TECHNICAL BULLETIN No. 0106

Oil Cooler Provision C20/TC20 Transmissions

Figure 1. Oil Cooler Tubing Stubs

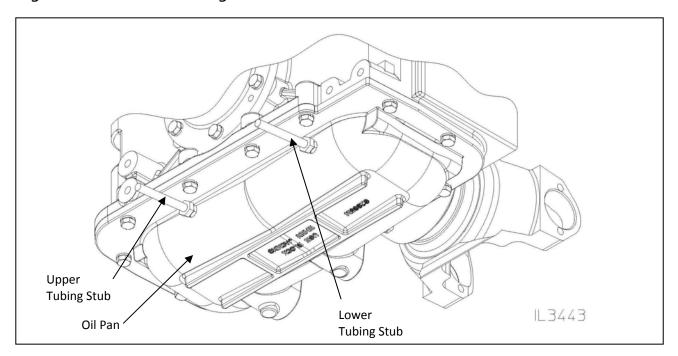
Effective November 20, 2009, all C20/TC20 transmissions are equipped with an oil cooler provision.

Note that the oil cooler provision consists of a copper cooling line inside the transmission oil pan.

1. Two (2) 3/8-inch copper tubing stubs extend from the transmission oil pan (see Figure 1) for connection to a water supply (see Step 2). Tubing stubs may be shortened as necessary for best fit; however, sufficient length must be available for use with compression fittings. If tubing stubs are shortened, the cut end must be deburred to ensure full inside diameter of the tube is visible.

Figure 2. Waterous Drain Valves

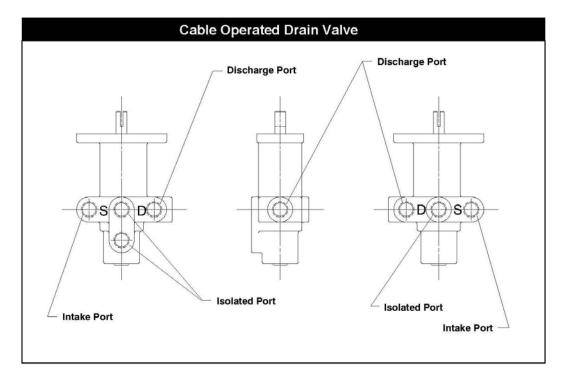
- 2. Connect oil cooler to a water supply as follows:
 - a. On units equipped with a Waterous cable operated drain valve (see Figure 2), connect one tubing stub to a "Discharge" port on the drain valve and the other tubing stub to an "Intake" port. **DO NOT** connect either stub to an "Isolated" port.
 - b. On units not equipped with a Waterous drain valve, connect one tubing stub to an opening on the pump discharge. Connect the other tubing stub to an opening on the pump intake. Openings must be 1/4-inch NPT minimum to ensure adequate water flow through the cooler. Provisions must be made to drain the cooler at the lower tubing stub.

IMPORTANT: Use 3/8-inch minimum tubing and fittings to connect to tubing stubs. Make sure all plumbing lines are free of low points to ensure proper drainage.
